Recall Bulletin

PRODUCT SAFETY RECALL

SUBJECT: Harsh Transmission Shift, Engine Stall, Engine May Not Start, MIL or Service Engine Soon Lamp

MODELS: 2005-2008 Pontiac Vibe
Two Wheel Drive Equipped with 1.8L MFI Engine (LV6)

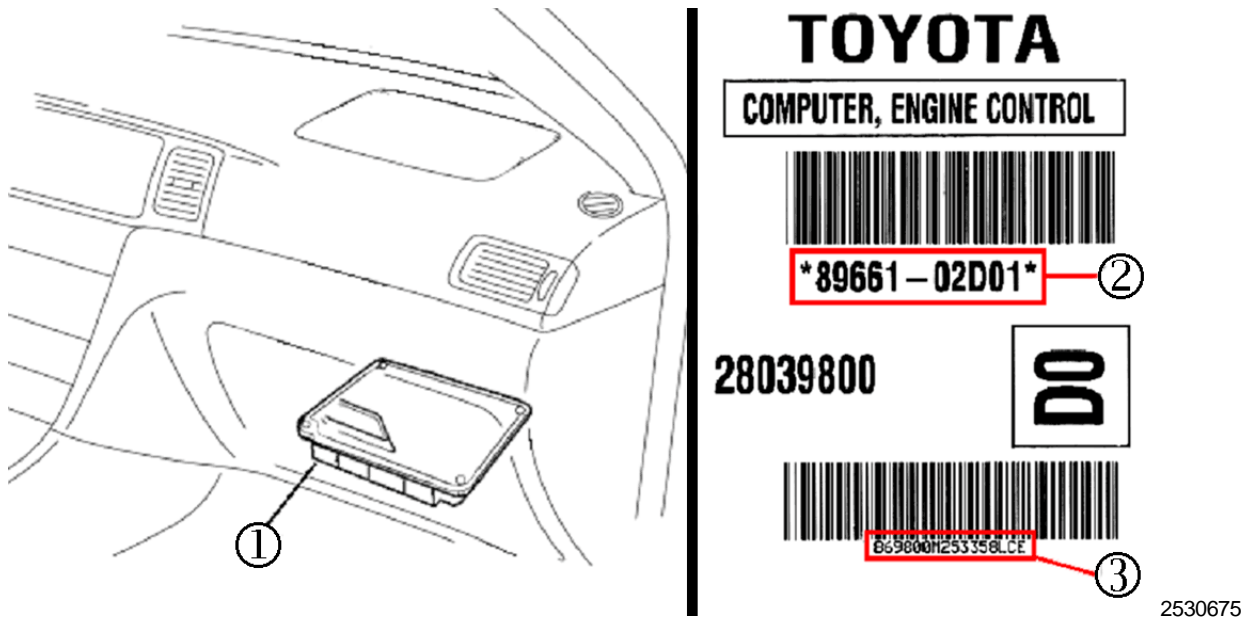
1. Locate the PCM (1) under the glove box compartment.
2. Record the part number (2) and the lot number (3) on the repair order.
3. Confirm the PCM part number to determine the required action using the table below.

4. Confirm the LOT number, if required. Determine the 9th through 12th digits as shown in the following example:

869800M2**5335**8LCE.

- If the LOT number is 7227 or higher, no further action is required.
- If the LOT number is 7226 or lower, replace the PCM. Refer to *PCM Replacement* in this bulletin.

Part Number	Action	New Part Number
89661-0112#	Replace the PCM	19205364
89661-0113#	Replace the PCM	19205366
89661-02D1#	Replace the PCM	19205365
89661-02D4#	Replace the PCM	19205364
89661-02D5#	Replace the PCM	19205366
89661-02K12	No Further Action Req'd	N/A
89661-02K22	No Further Action Req'd	N/A
89661-02K30	Replace the PCM	19205364
89661-02K31	Confirm the LOT Number	19205364
89661-02K32	No Further Action Req'd	N/A
89661-02K40	Replace the PCM	19205366
89661-02K41	Confirm the LOT Number	19205366
89661-02K42	No Further Action Req'd	N/A

Part Number	Action	New Part Number
89661-02K50	Replace the PCM	19205365
89661-02K51	Confirm the LOT Number	19205365
89661-02K52	No Further Action Req'd	N/A
89661-02Q91	No Further Action Req'd	N/A
89661-02R01	No Further Action Req'd	N/A
89661-02R10	Confirm the LOT Number	19205371
89661-02R11	No Further Action Req'd	N/A
89661-02R40	Confirm the LOT Number	19205370
89661-02R41	No Further Action Req'd	N/A
89661-02R50	Confirm the LOT Number	19205372
89661-02R51	No Further Action Req'd	N/A
89661-0Z04#	Replace the PCM	19205365
